UNITED STATES PATENT AND TRADEMARK OFFICE

APPLICATION NO.	FILING DATE	FIRST NAMED INVENTOR	ATTORNEY DOCKET NO.	CONFIRMATION NO.
10/733,321	12/12/2003	Dennis Erickson	S758 0002/TAR	9077

Office Action Summary	Application No.	Applicant(s)	
	10/733,321	ERICKSON ET AL.	
	Examiner	Art Unit	
	Yvonne M. Horton	3635

DETAILED ACTION

**Fig. 9**

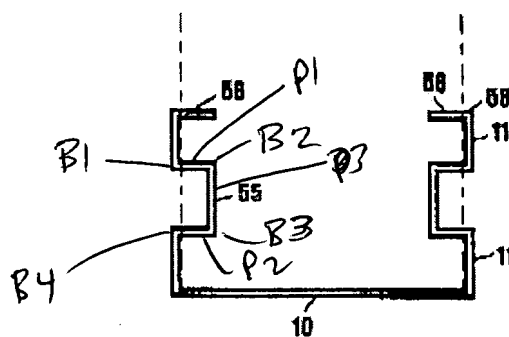
edge thereof with three bends. "STEELER INC. – Deflection Track" discloses the basic claimed track except for the particulars of the deformable portion. SUROWIECKI, figure 9 teaches the use of a track (10) wherein the deformable portion includes at least four bends (B1-4). It would have been obvious to one having ordinary skill in the art at the

time the invention was made to provide the track of "STEELER INC. – Deflection Track" with the four bend portion of SUROWIECKI in order to provide the track with more versatility in bending. Regarding claims 2,12,21,41,45,48, the deformable portion (D) consists of a unitary piece of material and is resiliently deformable using one or more legs. In reference to claims 3,5,5,7,18,34,43,44,47,49,50-55, the deformable portion (D) allows the track to compress in the longitudinal direction and expand orthogonally. In regards to the angles formed in the deformable portion, it would have been obvious to one having ordinary skill in the art at the time the invention was made to select an angle suitable for the use intended as an obvious matter of design choice. For instance, in areas where earthquakes are common perhaps an angle that is wider to compensate for the extra forces imposed thereon would be appropriate. Regarding claims 4,13,14,16,22-26,29,30, the deformable portion (D), as modified by SUROWIECKI has

a first angled portion (P1), a second angled portion (P2) and a central portion (CP) between the four bends (B1-4), and a flat portion (FP) between deformable portions (D) wherein the deformable portion extends outwardly of the track and the track is coupled to opposite ends of another track near the flat portions (FP).

EXAMINER'S ATTACHMENT

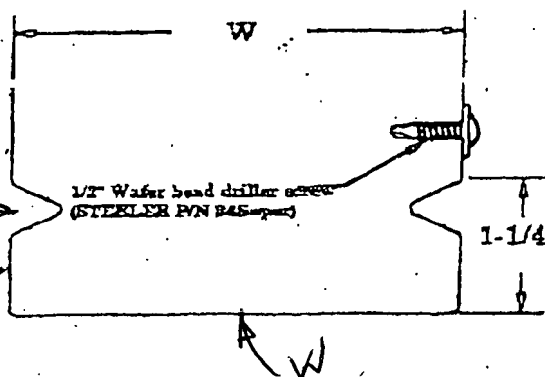
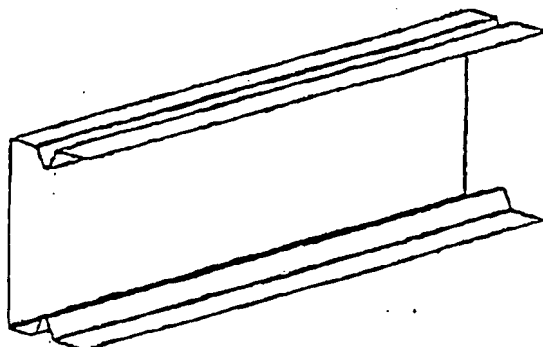
Claims 1-7,12-14,16,18,21-26,29,30,41,43-45,47-55 are rejected under 35 U.S.C. 103(a) as being unpatentable over "STEELER INC. – Deflection Track" in view of US Patent #6,374,558 to SUROWIECKI. In reference to claims 1,43,47,53-55, "STEELER INC. – Deflection Track" discloses a track including a web (W) and one or more deformable legs (L), see attachment, having a deformable portion (D) at a distal
